CALCULATED	MJB
	CHECKED
PSB	
PAVEMENT SUBSUMMARY	
MED - 3 - 09 . 04	
18 80

MED - 3 - 09 - 04

ROUNDABOUT SPLITTER ISLAND DETAILS

**ROUNDABOUT
INTERSECTION DETAIL**

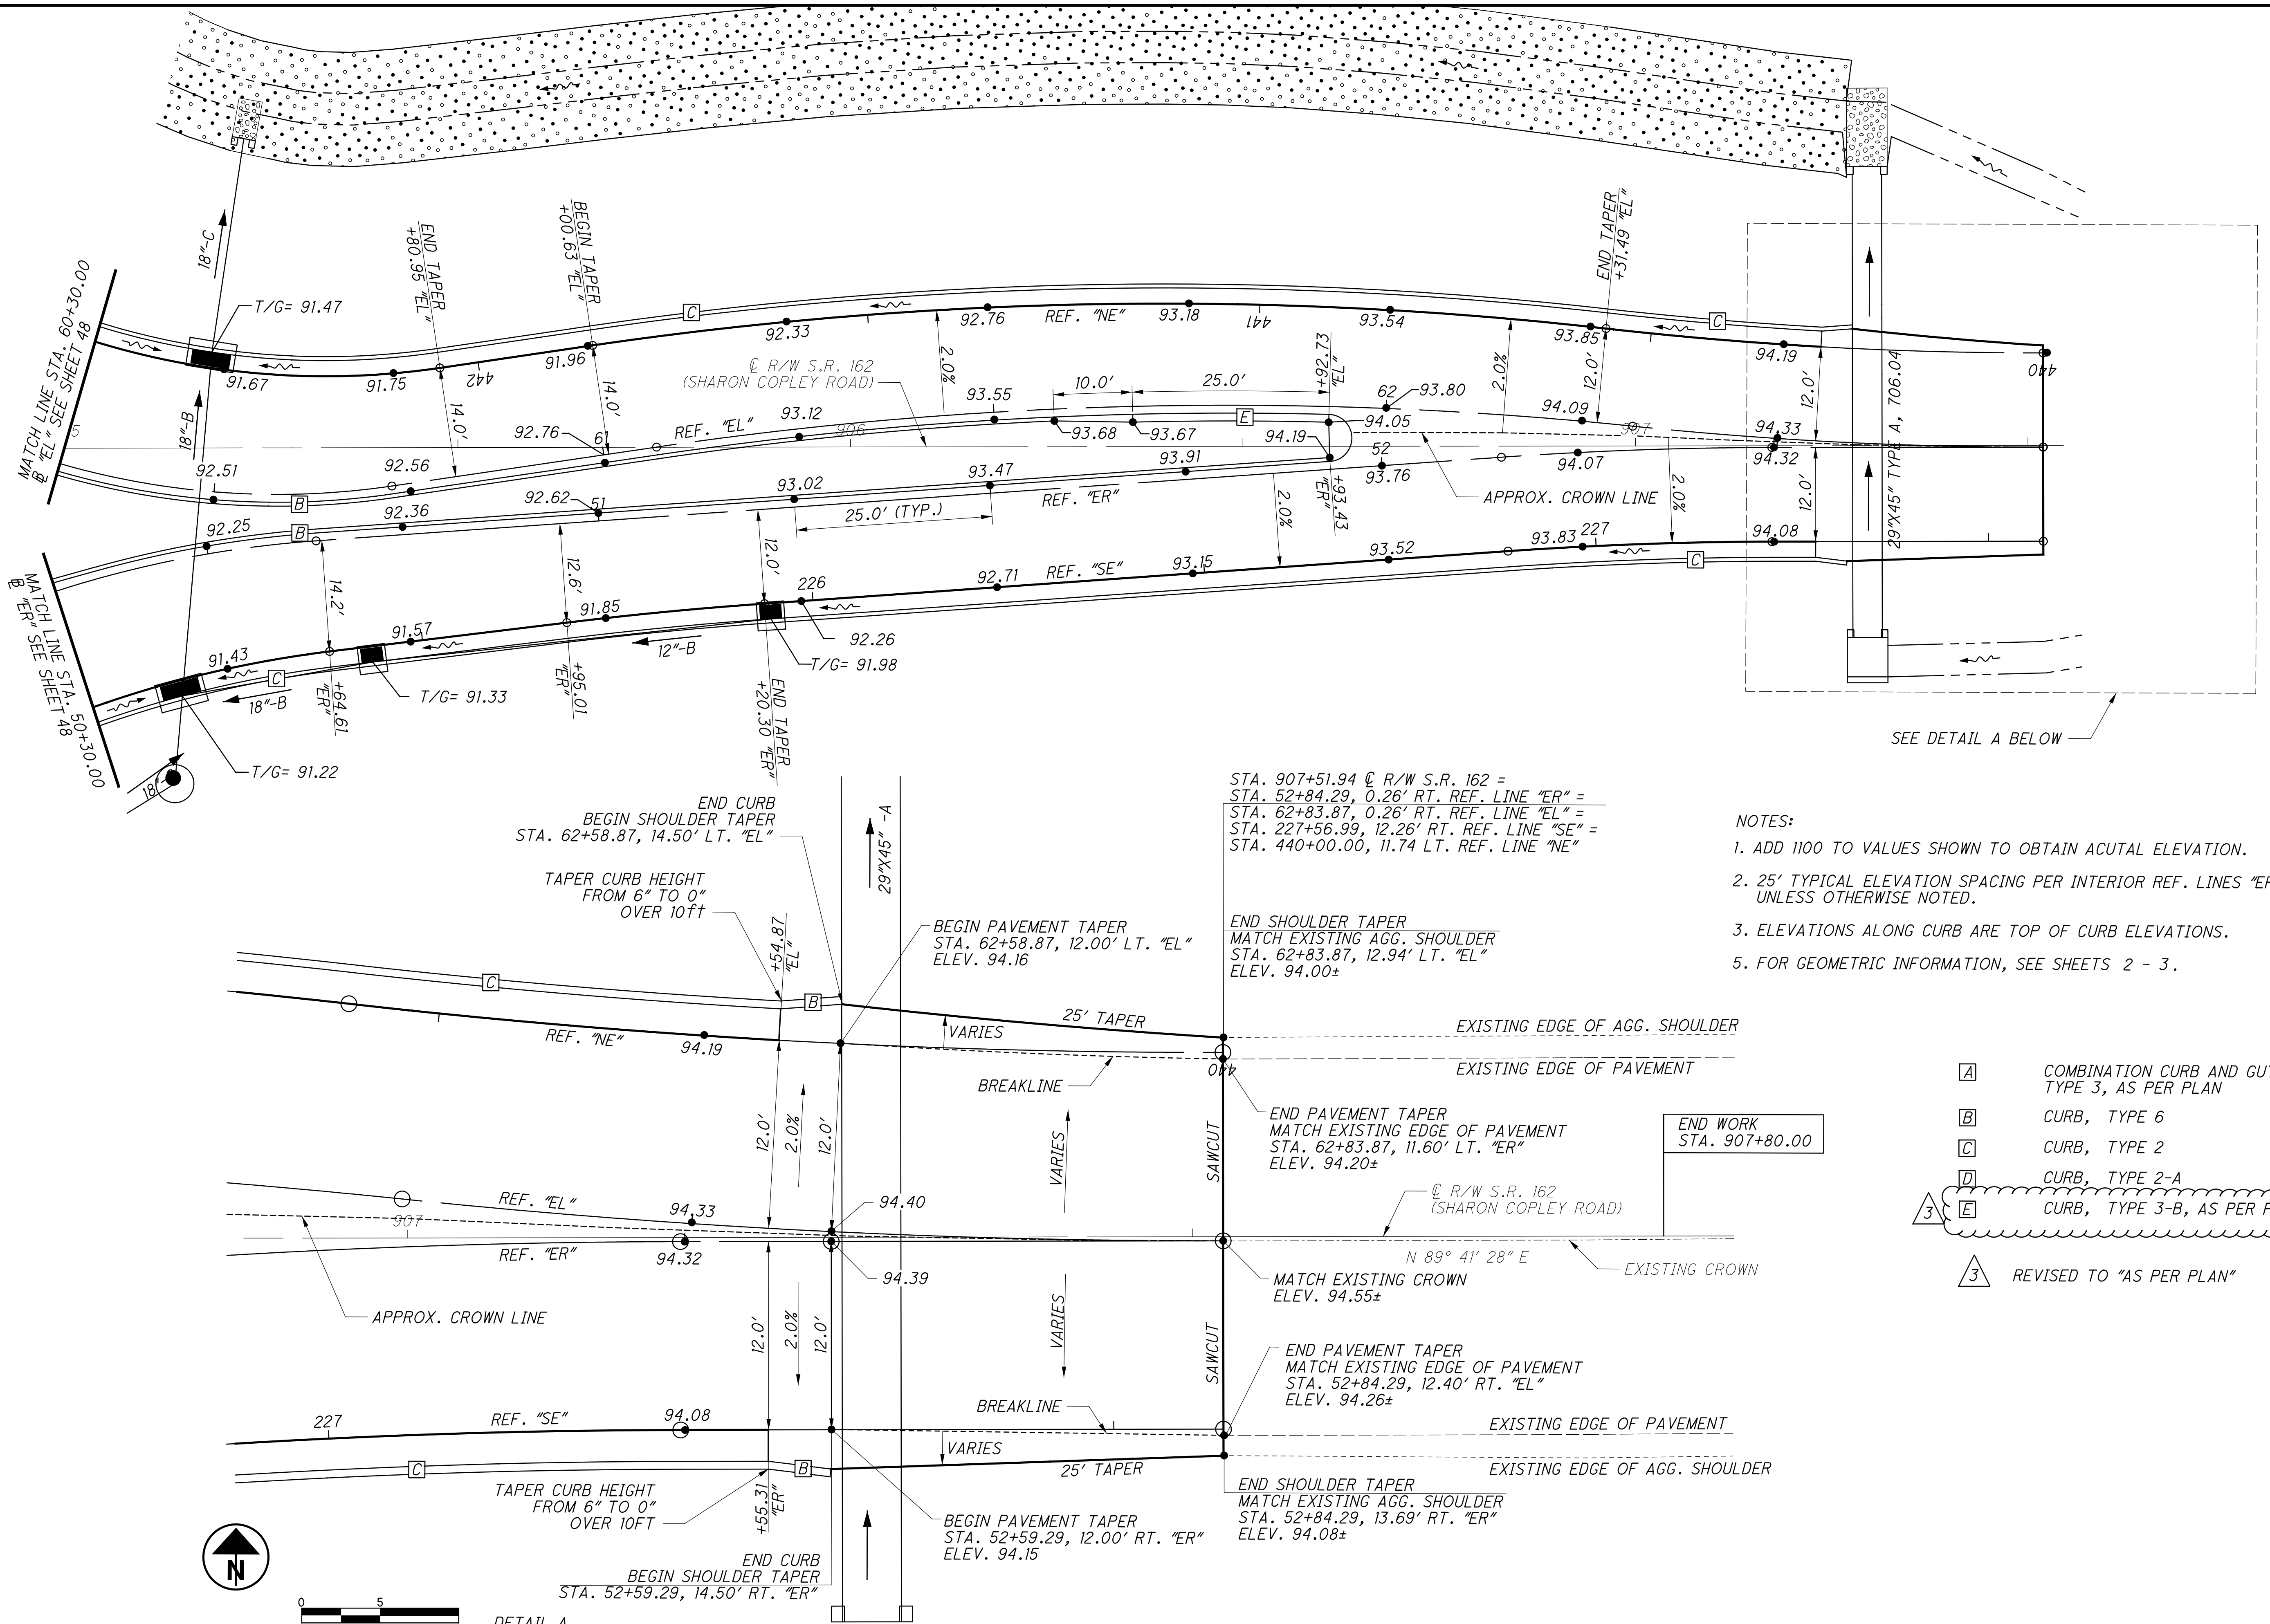
3 REVISED TO "AS PER PLAN"

S.R. 3 NORTH

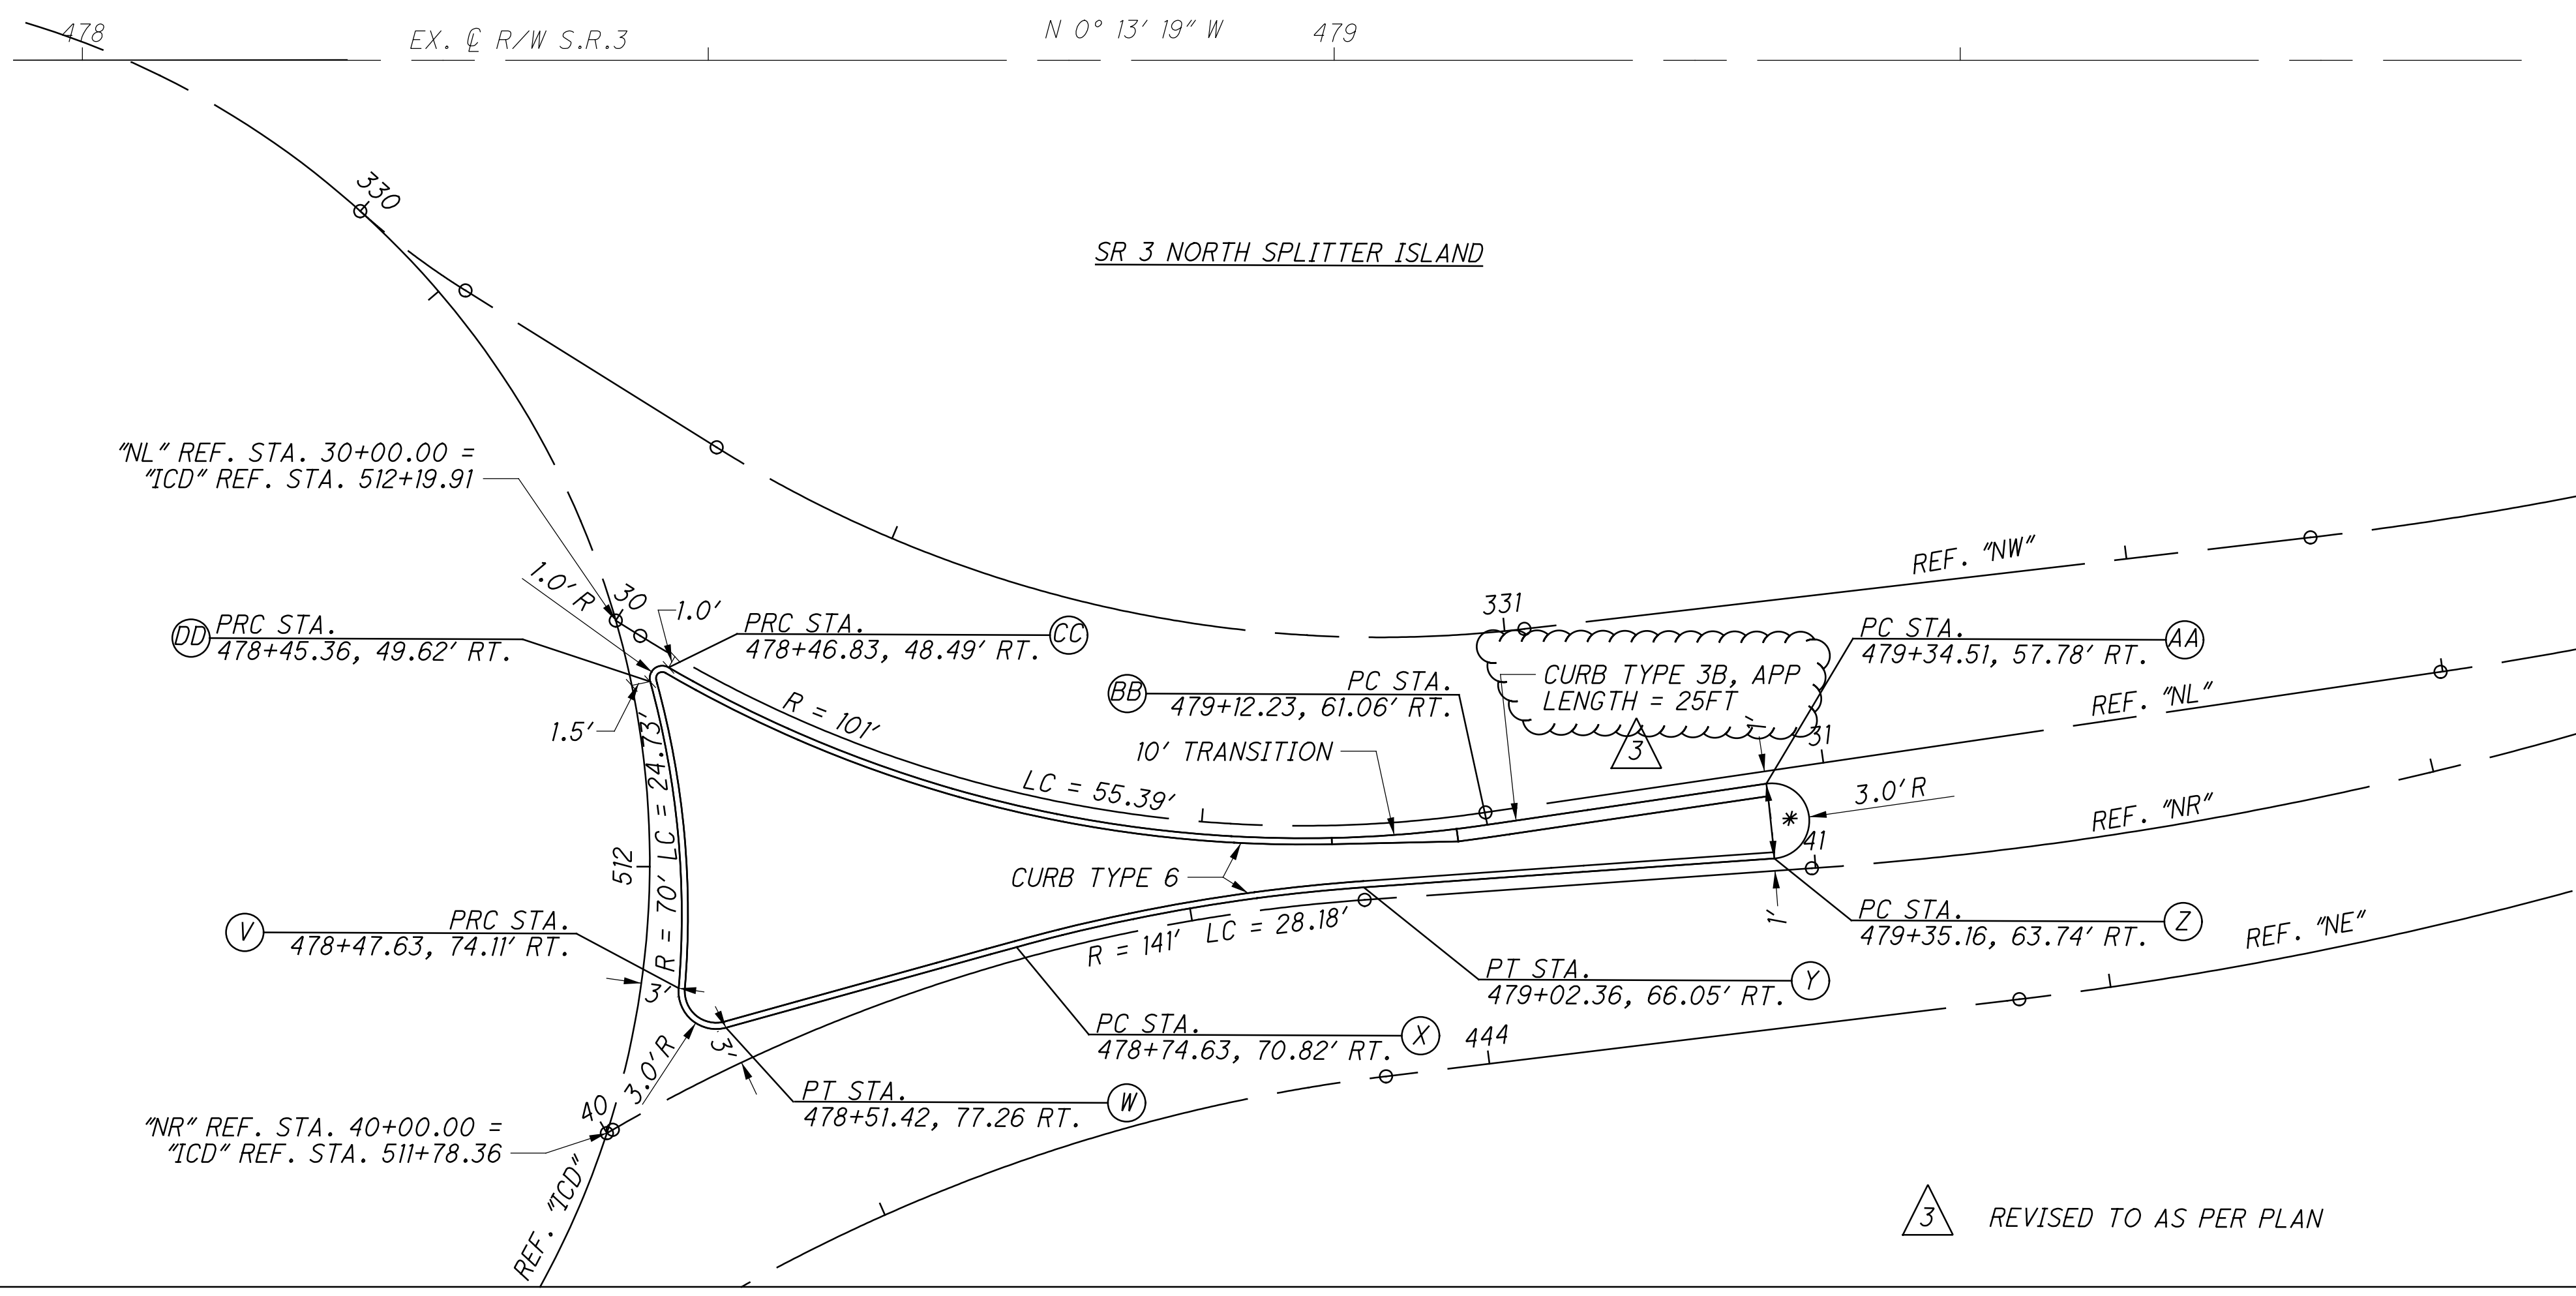
3 REVISED TO AS PER PLAN

S.R. 3 SOUTH

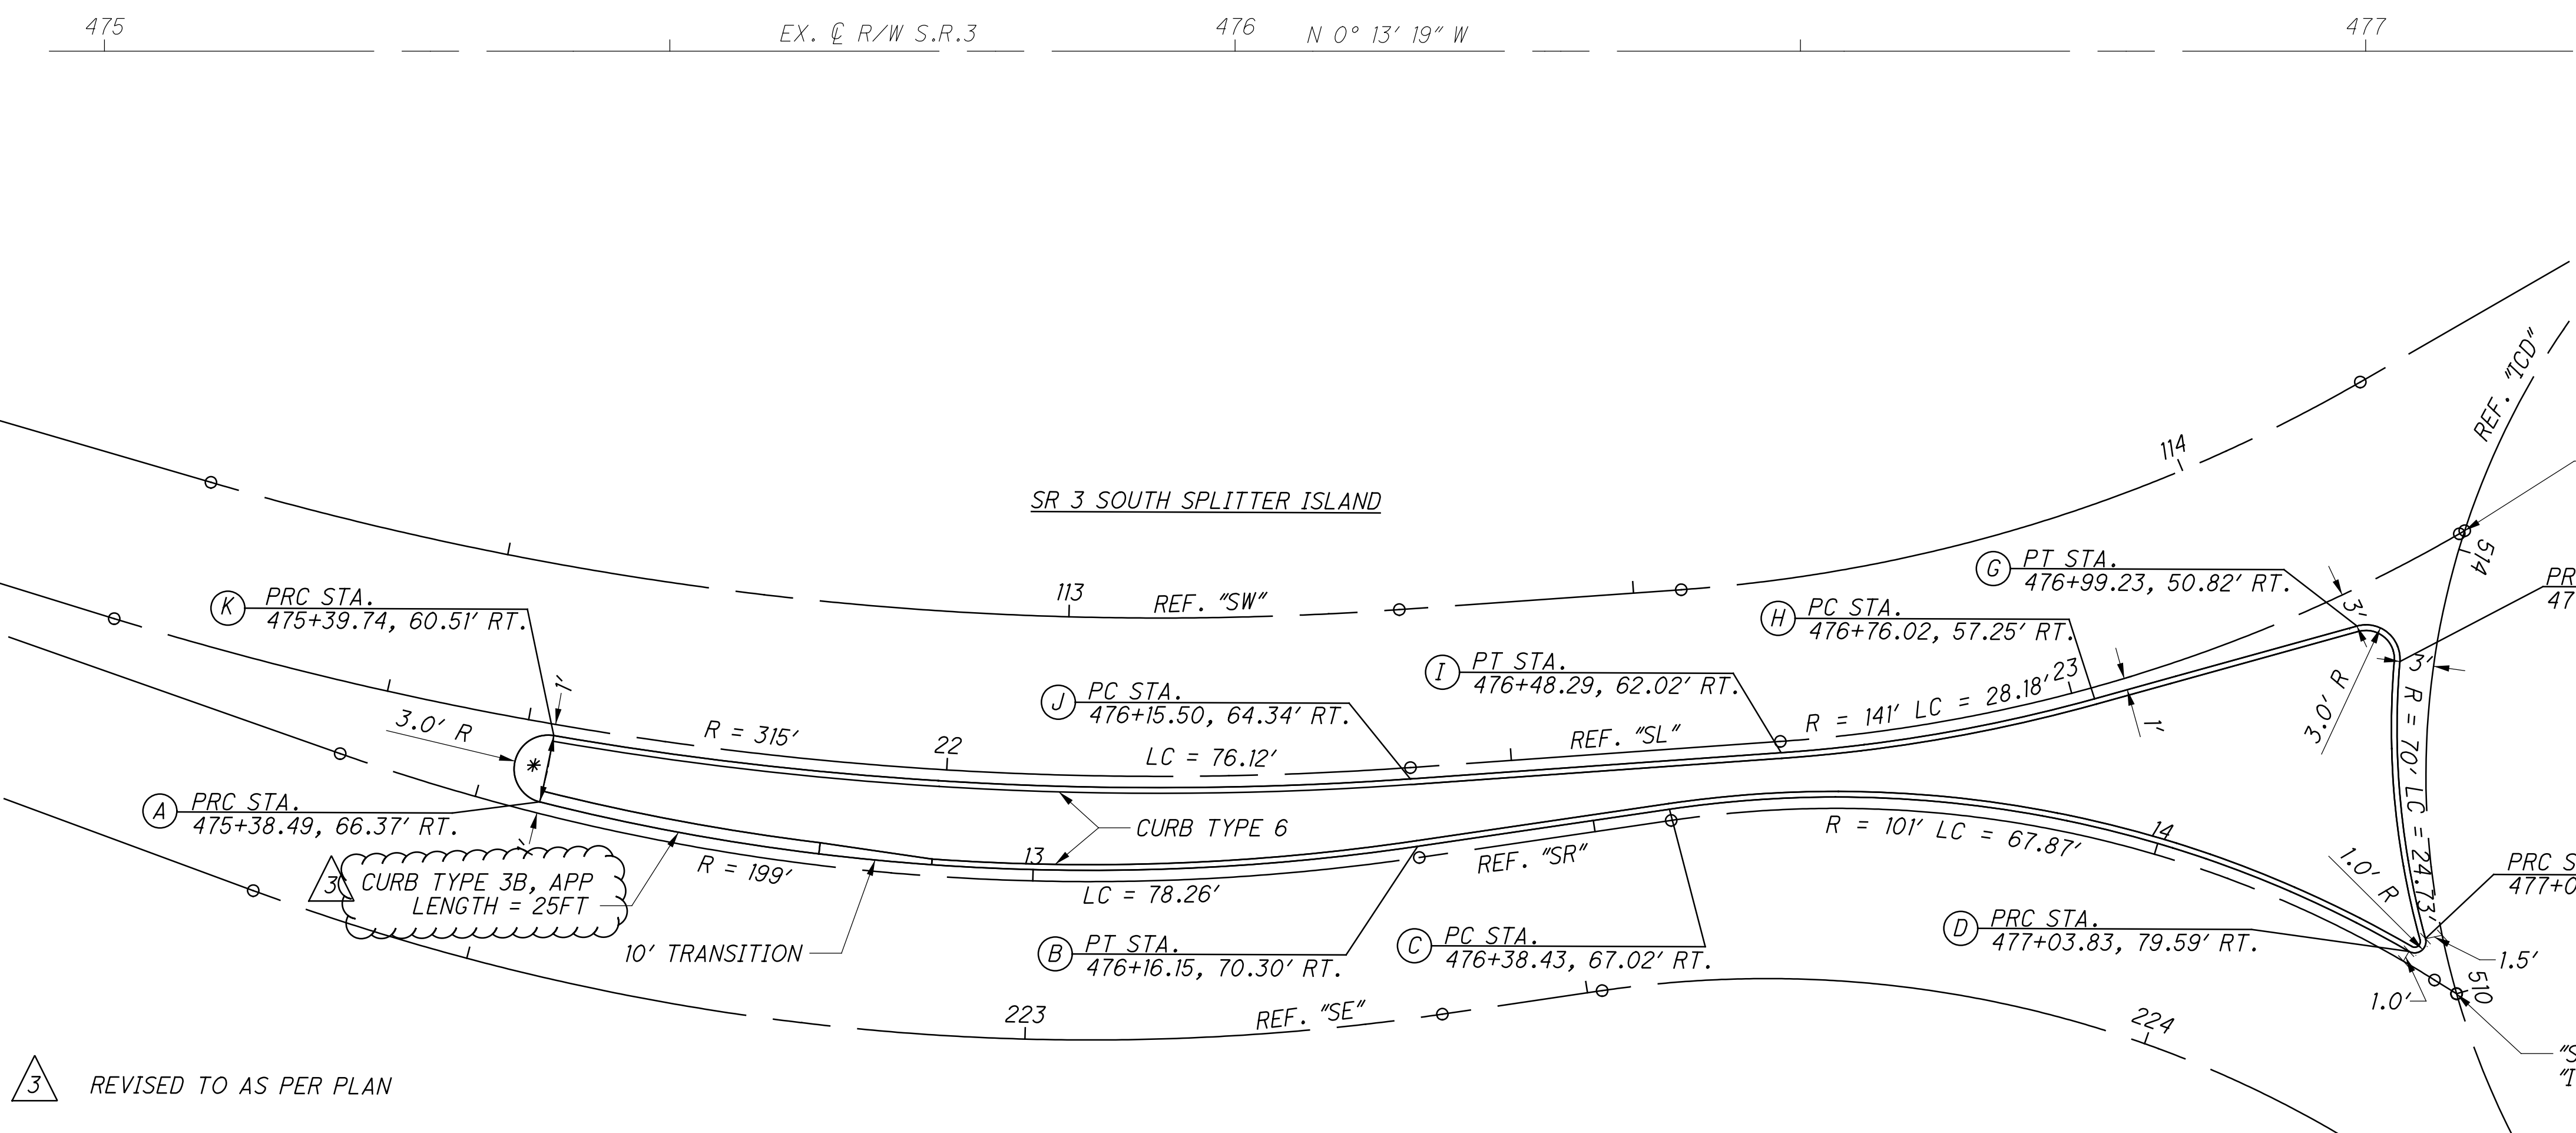
3 REVISED TO AS PER PLAN
